*Presentation to U.S. EPA Region 5 by the
Trustees of the Environmental Conservation
and Chemical Corporation Site Trust Fund*

THE RRA AT THE ENVIRO-CHEM SITE ZIONSVILLE, INDIANA

14 August 1997

REVISION 2

ENVIRONMENTAL CONSERVATION AND CHEMICAL CORPORATION TRUST	ENVIRO-CHEM SUPERFUND SITE PHASE I S.V.E. LAYOUT
PROJECT NO. PROPOSAL	SCALE 1" = 30'-0"
DRAWING NO. L9707101	SHEET 2 OF 4

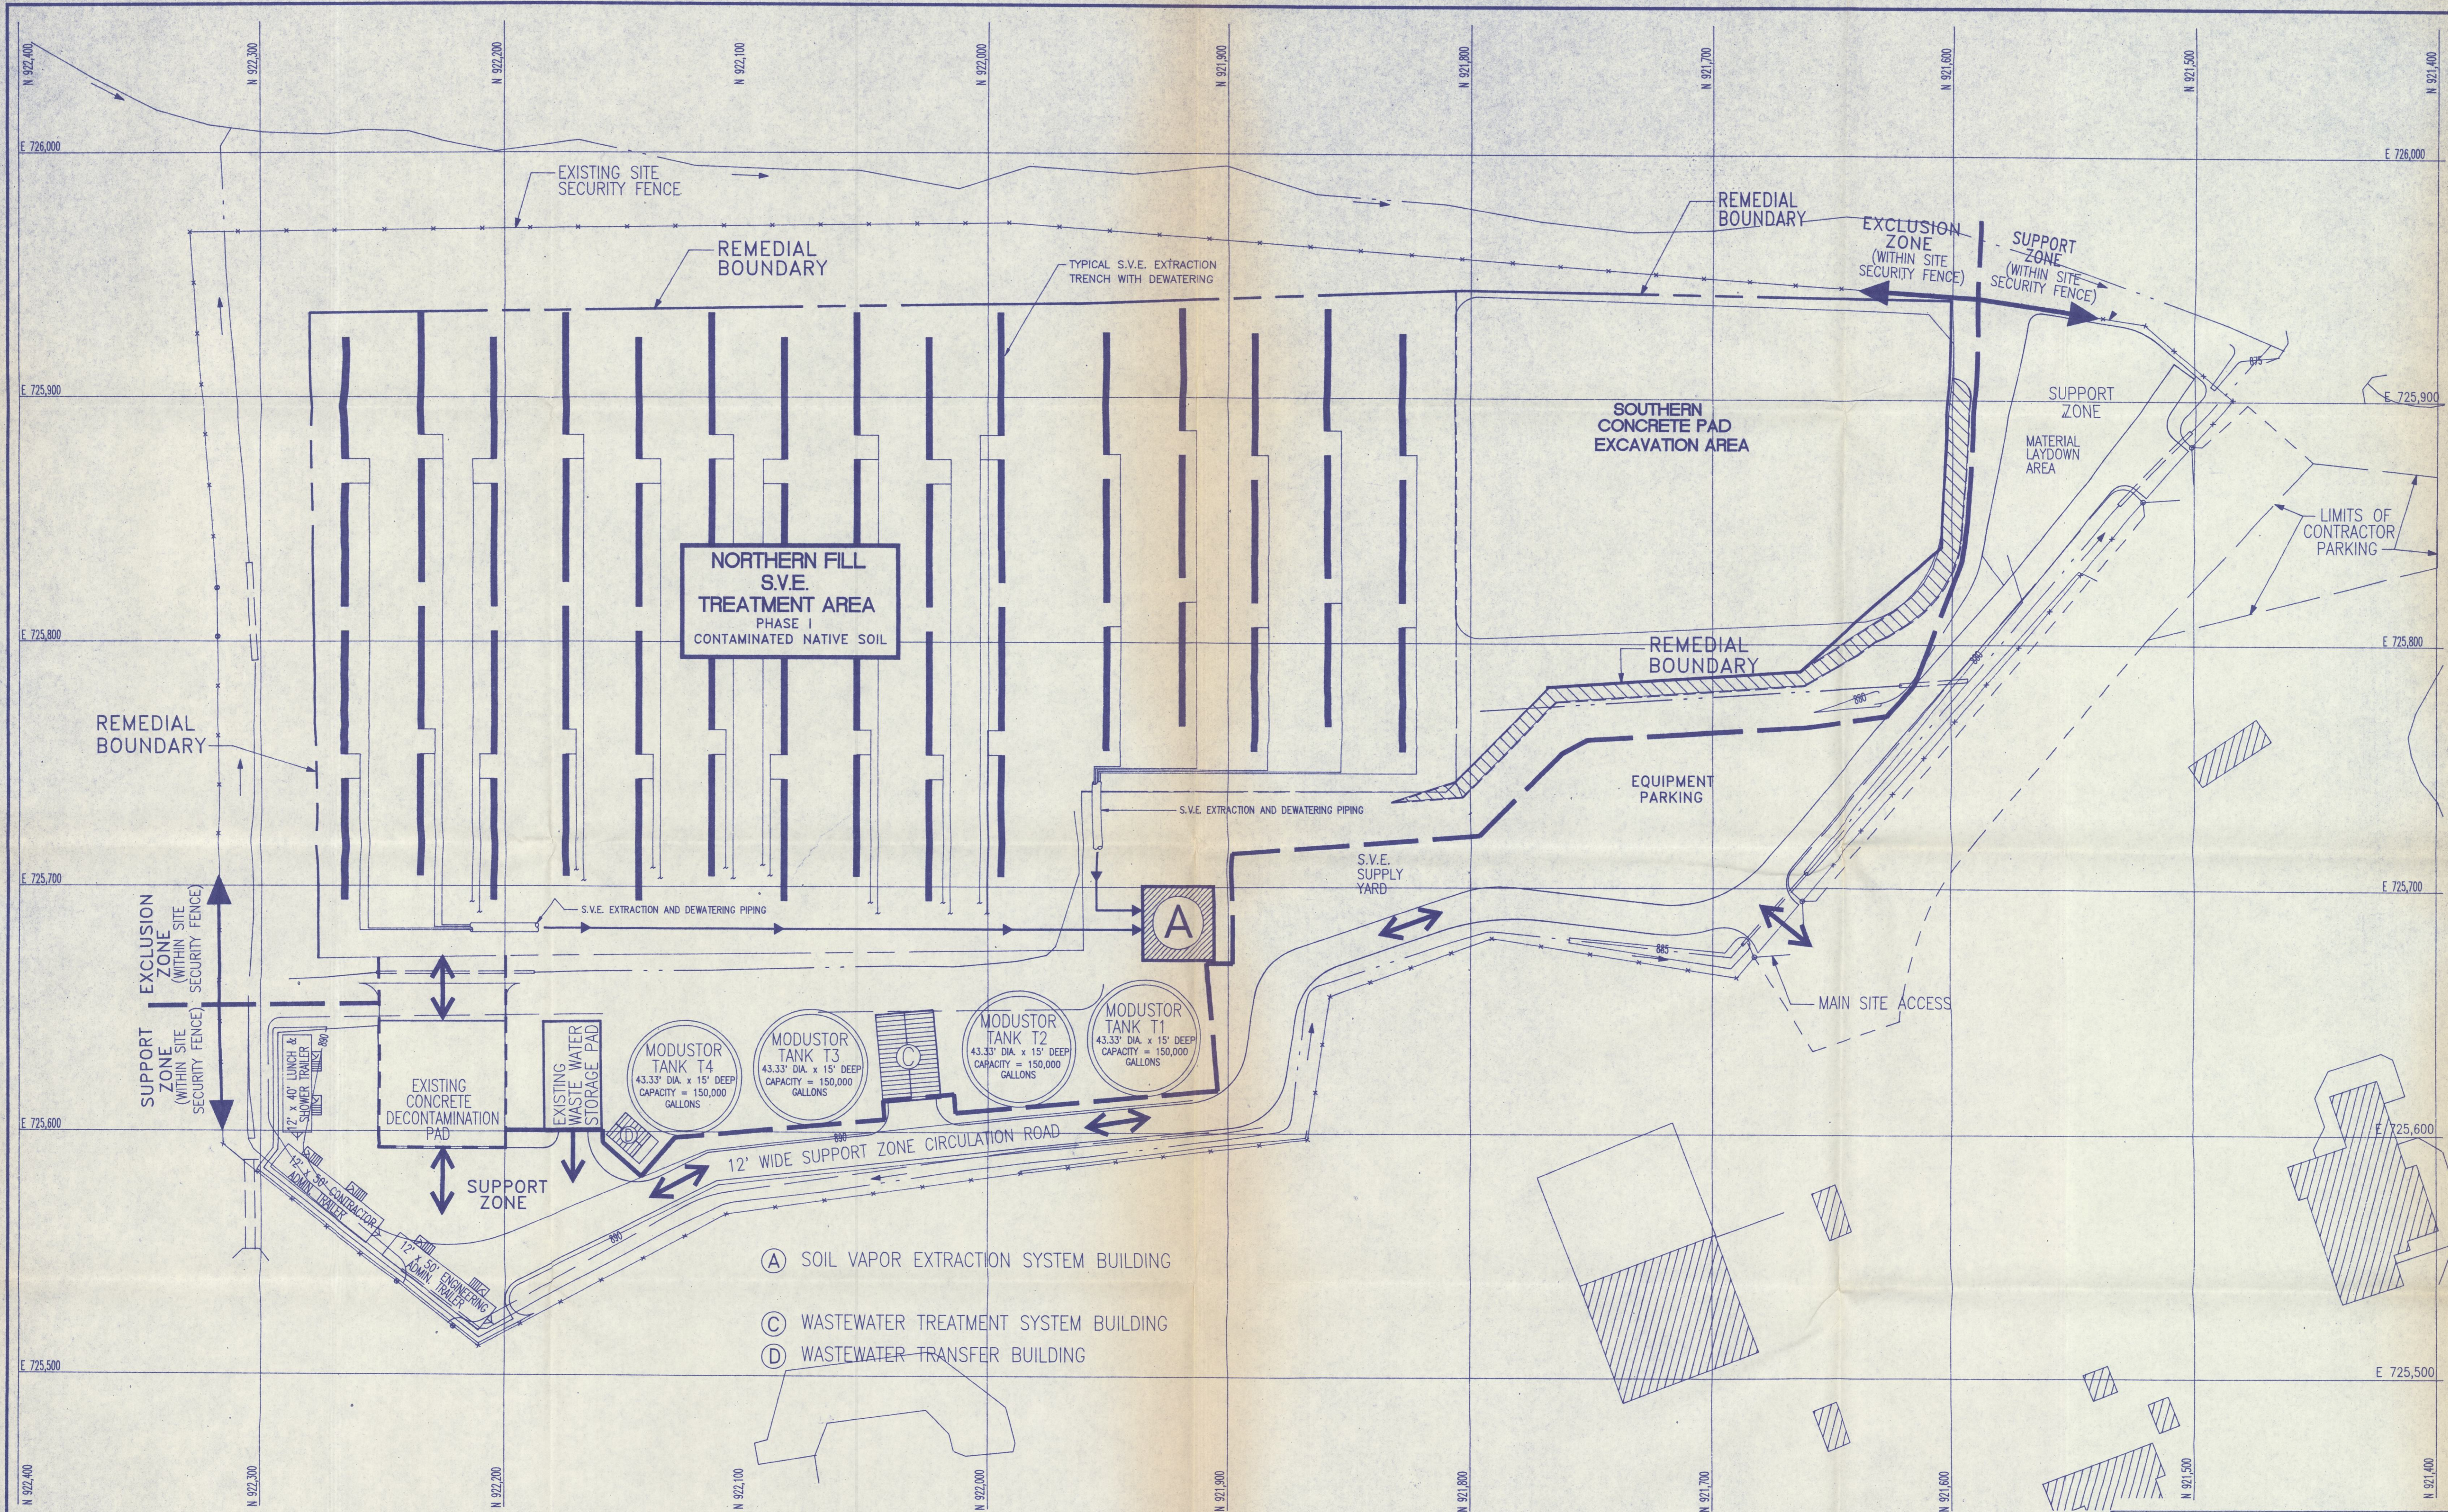
back-filled. The vent pipes will be installed at a depth of two feet below grade. The trenches will be 40 feet long and backfilled with a high permeability gravel. The vent pipes will be two inch well screen, see VERSAR drawing, sheet 2. The trenches will be installed approximately 30 feet apart, allowing a venting radius of 15 feet from each trench area. Only two 2-inch trench screens will be connected to one 3-inch extraction line. Each of the 3-inch extraction lines will run directly to an influent header within the SVE blower building.

ENVIRONMENTAL CONSERVATION AND CHEMICAL CORPORATION TRUST		ENVIRO-CHEM SUPERFUND SITE PHASE II SVE LAYOUT
Versar Inc. 1900 FROST ROAD, SUITE 110 BRISTOL, PA 19007 (215) 788-7844		PROJECT NO. PROPOSAL DRAWING NO. L9707102 SHEET 3 OF 4

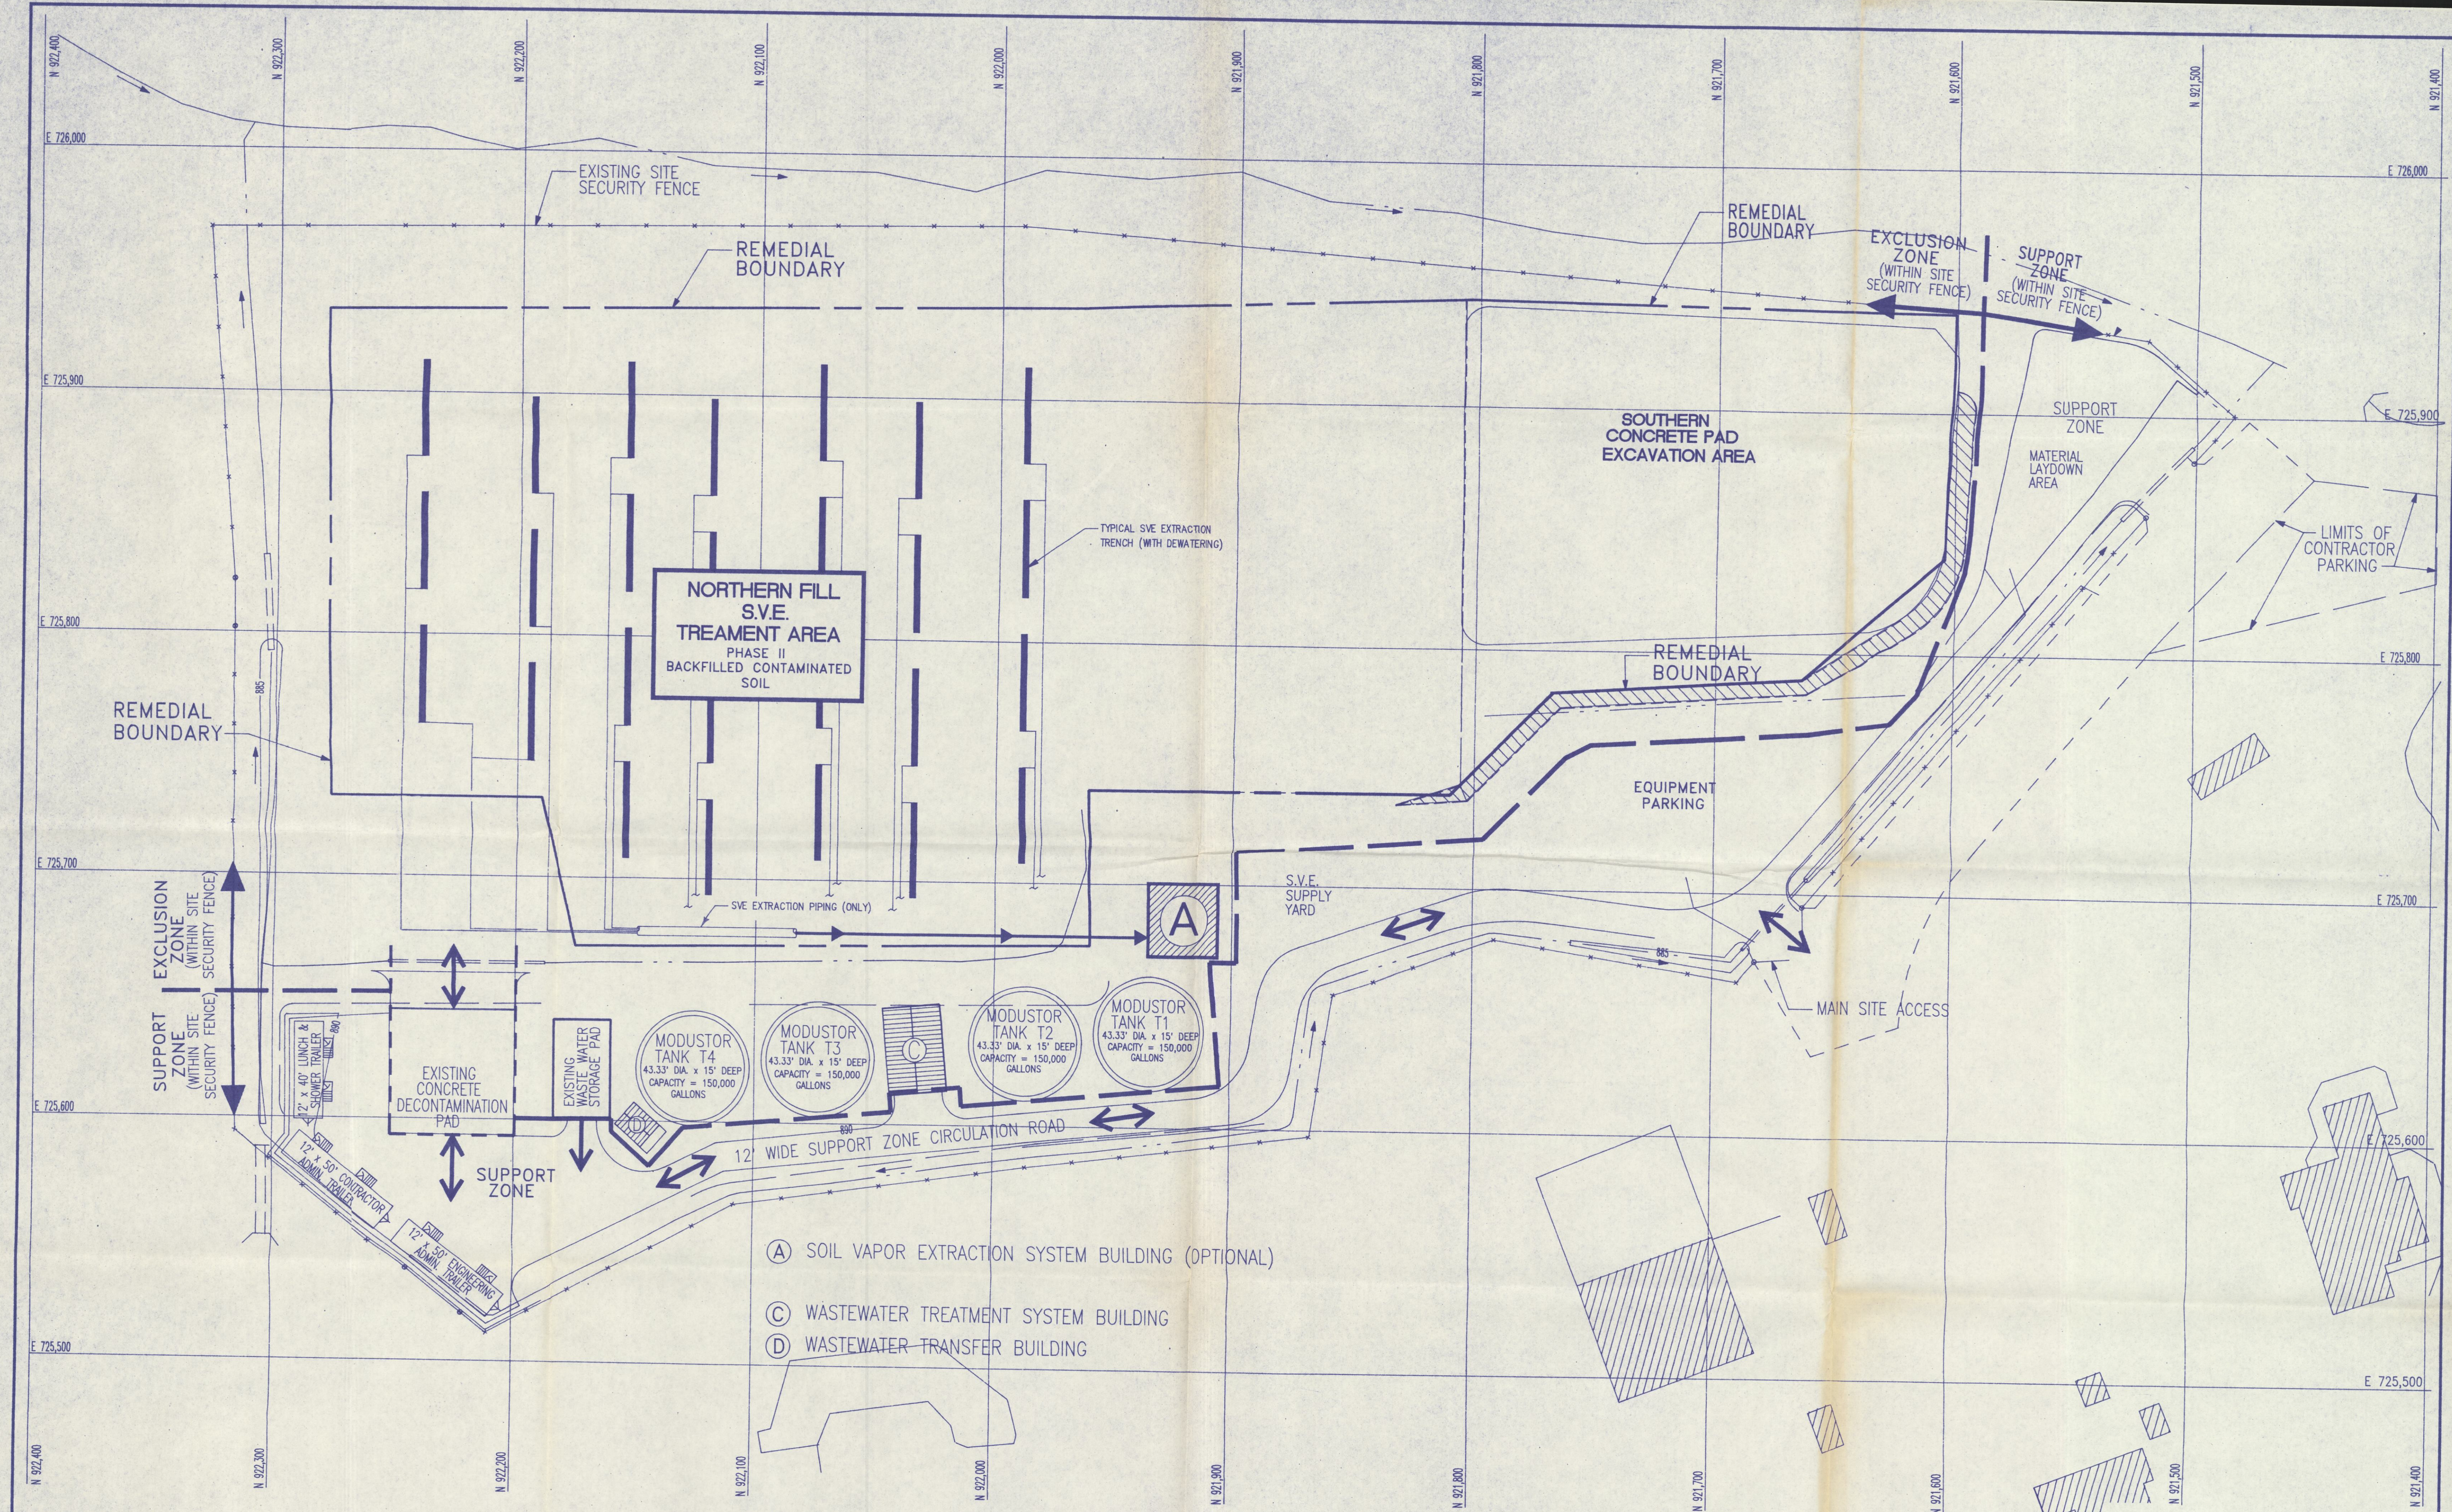
- c. An additional 26 SVE trenches will be installed within the upper section of the Northern treatment area. These trenches will be installed within the relocated soils from the southern excavation, see VERSAR drawing, sheet 3. The upper trenches will be isolated from the lower trenches, however, they will be constructed in a similar fashion. Two trench vents will be attached to one 3-inch extraction line. Each of the 3-inch extraction lines will run to an influent header in the SVE building. Due to the smaller volume of soil within the upper area, the trenches will extend only to one foot above the native soils or to a depth of approximately six feet. Also due to the anticipated higher permeability caused by reworking of the soils, the upper trenches will be approximately 50 feet long.
